Appendix D Subsidence Report Peer Review Letter

15th February 2022

**SUBJECT: Peer Review Outcomes – GGPL Mine Layout and Surface Subsidence Assessment
Report, Ensham Life of Mine Extension, Zones 2 and 3**

FIGURE 1. Factor of Safety vs Width:Height Ratio for Zones 2 and 3, Ensham LoM Extension Area

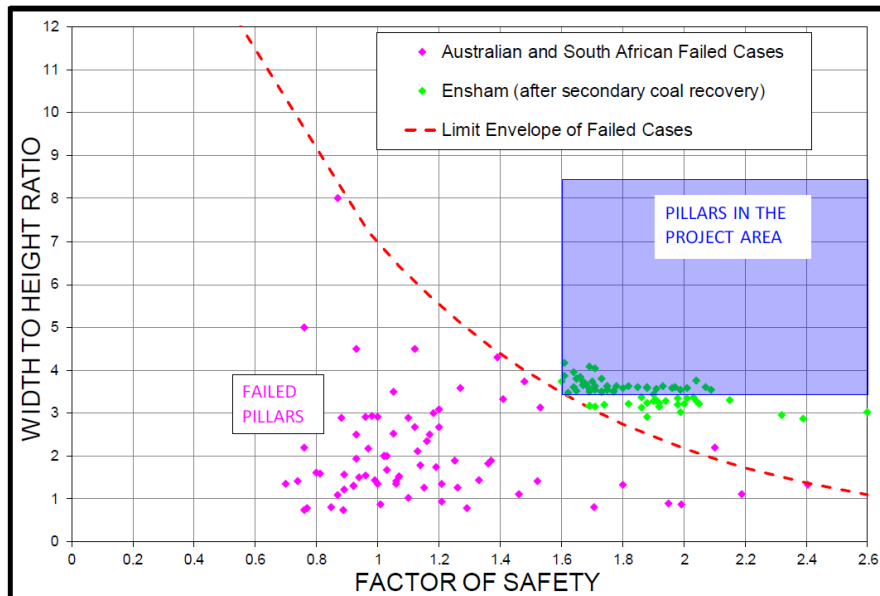
Figure 1, reproduced from the GGPL report, contains the range of pillar FoS and w/h ratio design outcomes within Zones 2 and 3 of the Life of Mine (LoM) Extension Area. As is clear from **Figure 1**, the proposed remnant pillar designs have no precedent in terms of a pillar collapse based on the **Hill 2005** combined pillar stability criteria of FoS and w/h. This design outcome is assessed to be a minimum requirement and needs to be supplemented with other relevant considerations in order to gain a more comprehensive understanding of the actual robustness of the proposed designs in terms of ensuring long-term stability of the remnant mine workings.
